Access Compliance Report

Public Rights-of-Way

| Intersection ID: 32299 | Main Street: HAZELVIEW_DR | Cross Street: OSWALD_LN | Location: NW |
| ADA ID: B098F52EF8DE | Ramp Type: PerpDiag | Initial Pass/Fail: Fail | Overall Compliance: No |

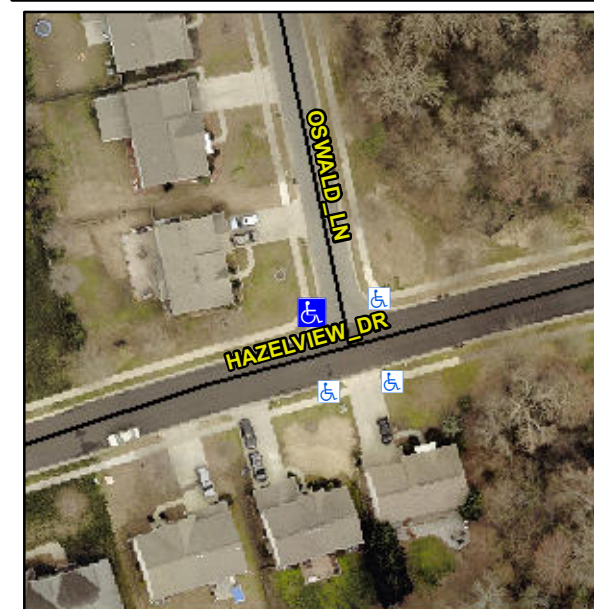
Not Found, R304.5.1, R304.2.2

| Compliance | Description | Data | Compliance | Description | Data |
|------------|-----------------------|------|------------|-----------------------------|------|
| N/A | Ramp Length (in) | 95.5 | No | Ramp Slope (%) | 12.6 |
| No | Ramp Width (in) | 37.0 | Yes | Ramp XSlope (%) | 2.0 |

Remove & Replace Curb Ramp With Two New Directional Ramps or Equivalent.
